## **Addendum No. 2**

### **INVITING SEALED BIDS ITB No. 21/10039**

#### **Project: West Campus Laboratories Bldg. F Renovation**

**Issue Date:** February 18, 2021

**PLUMBING PLAN - LEVEL 2  
AREA B - WATER & GAS -  
BASE BID**  
**P2.2.3**  
100% CONSTRUCTION DOCUMENTS

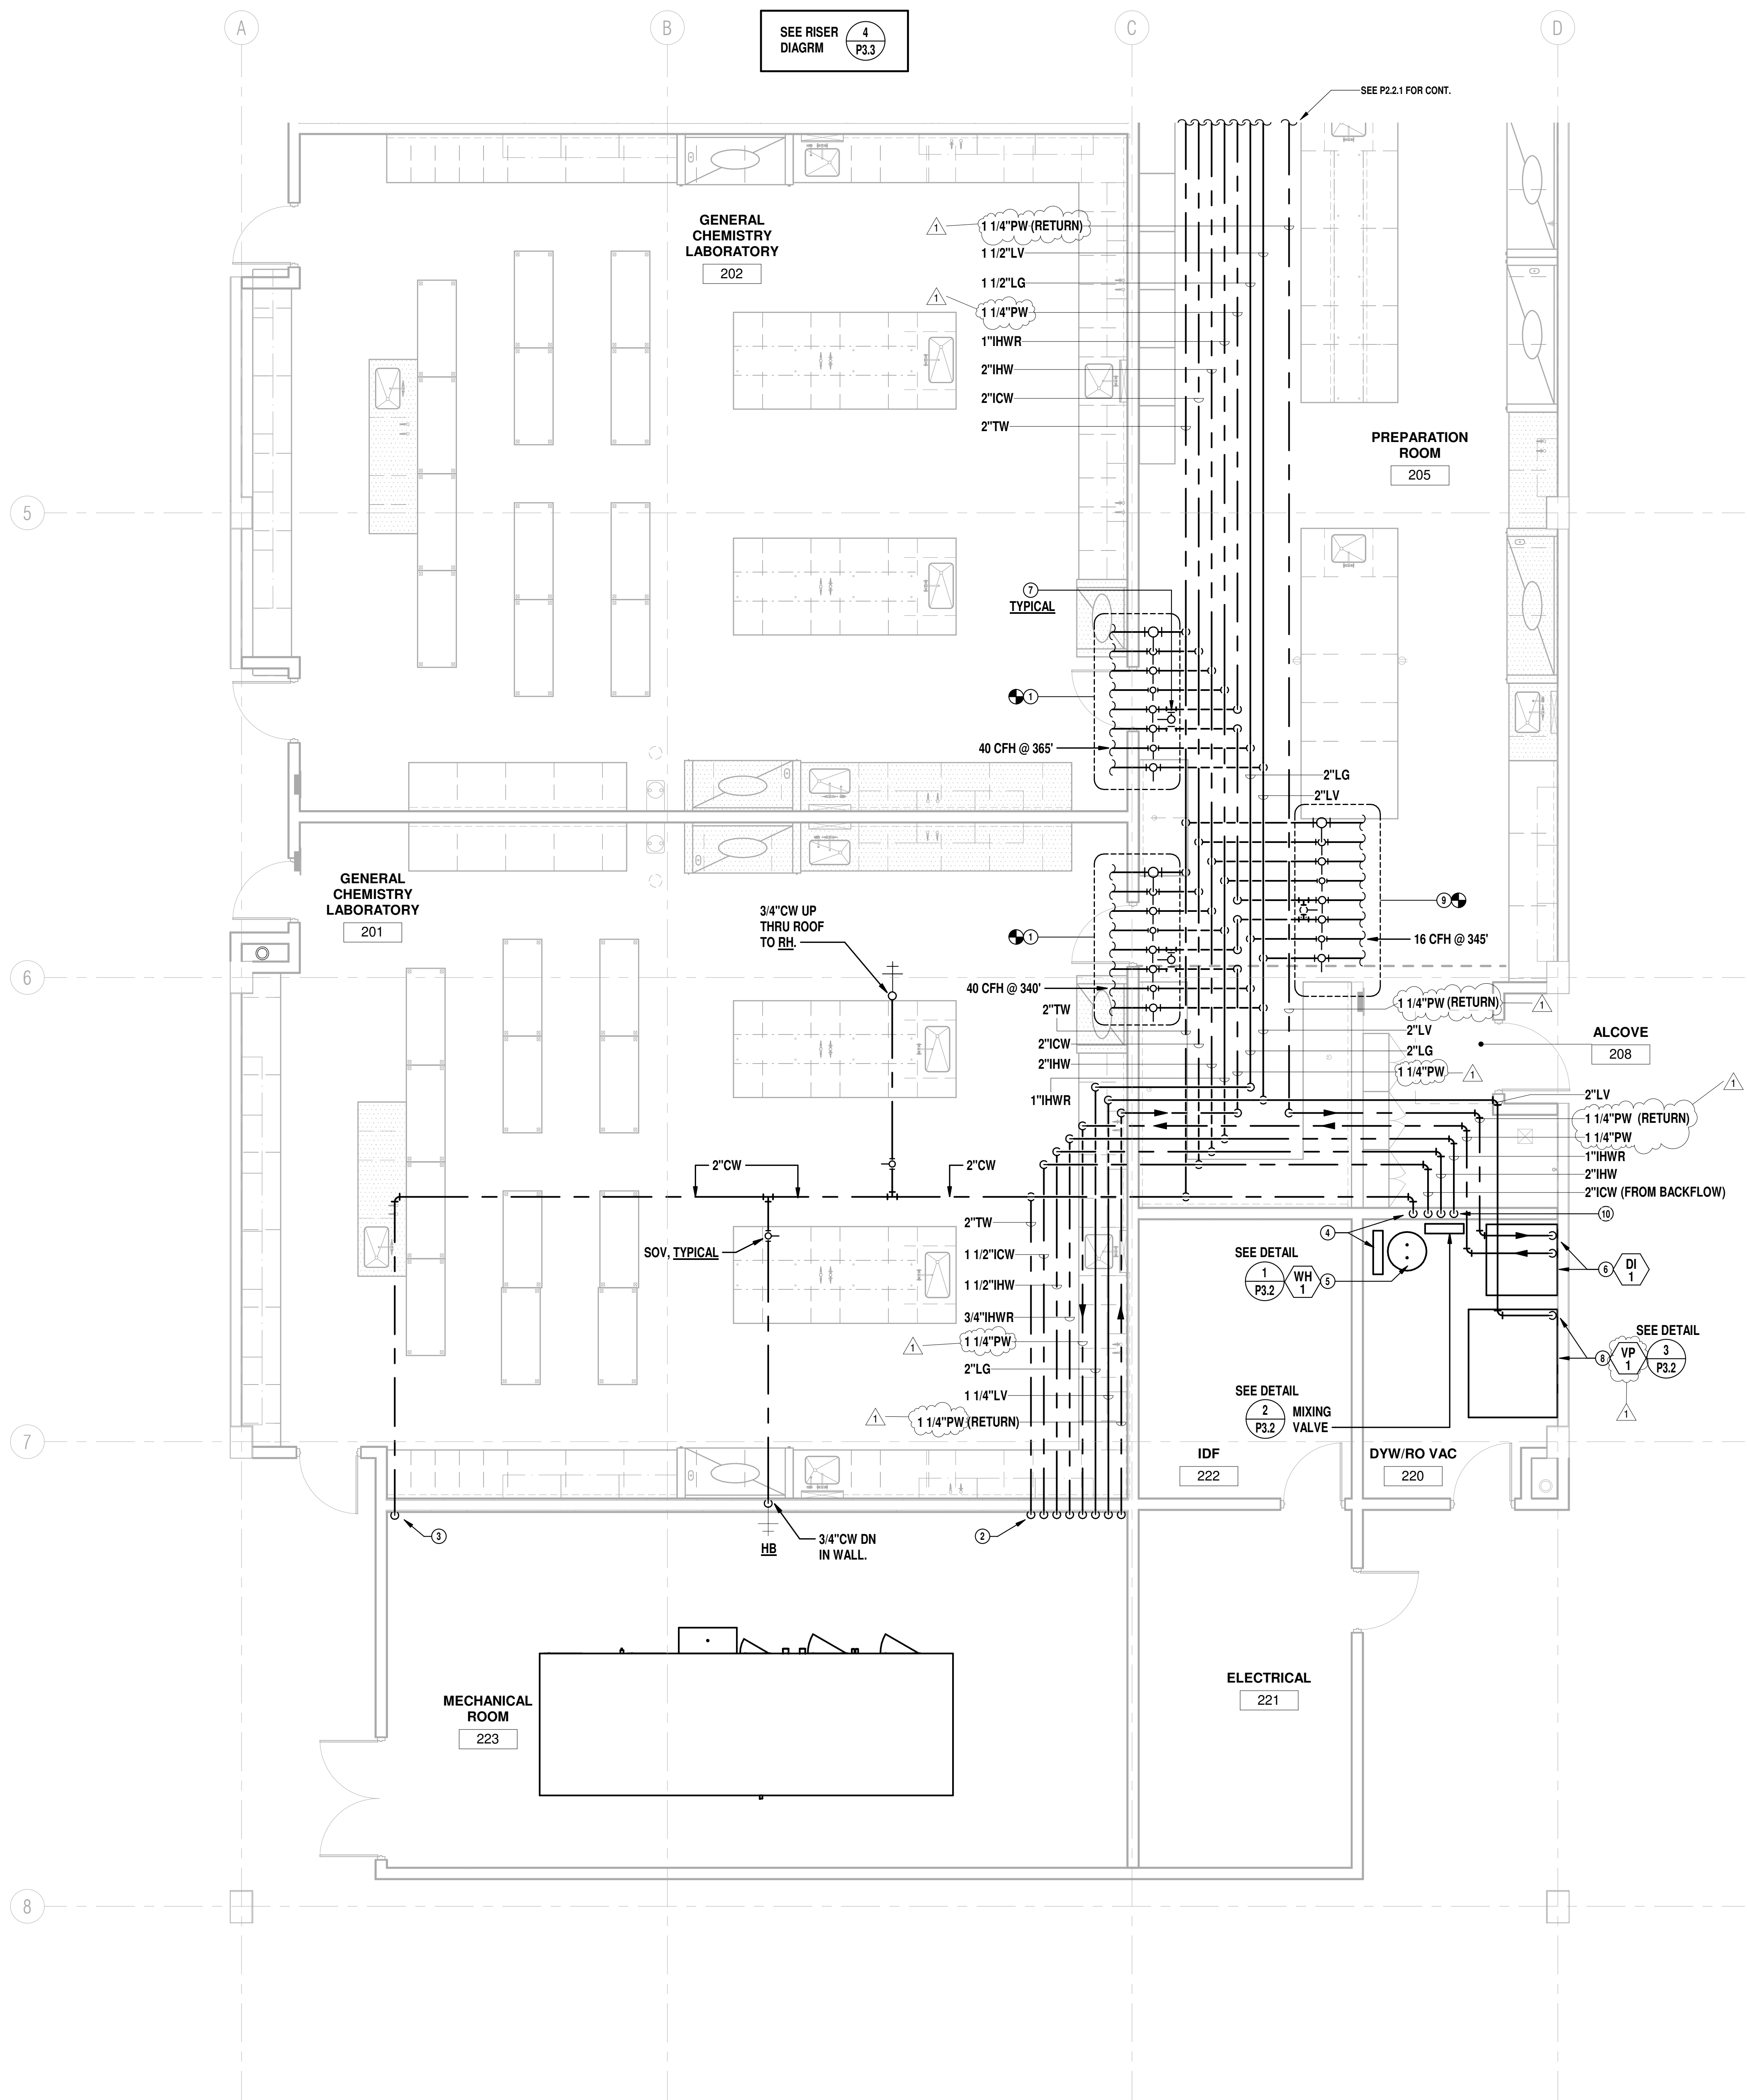
**Answer #8:** No shut-off valves into other buildings are located in Building F
- Question #9:** Fire risers – is the Contractor responsible for bringing in line and creating fire risers of Base Bid (Second Floor)? Are risers connected for Alternate 1, 2 and Base Bid? Or is the riser connection a T with Base Bid?

- Question #19:** Please Add Alternates to the MEP sheets they pertain to?
- Answer #19:** See Addendum 2 by BWS.
- Question #20:** Are the Add Alternates a pricing breakout? Or are they a true Add Alternate as if there is no funding for that work then that work will not happen?
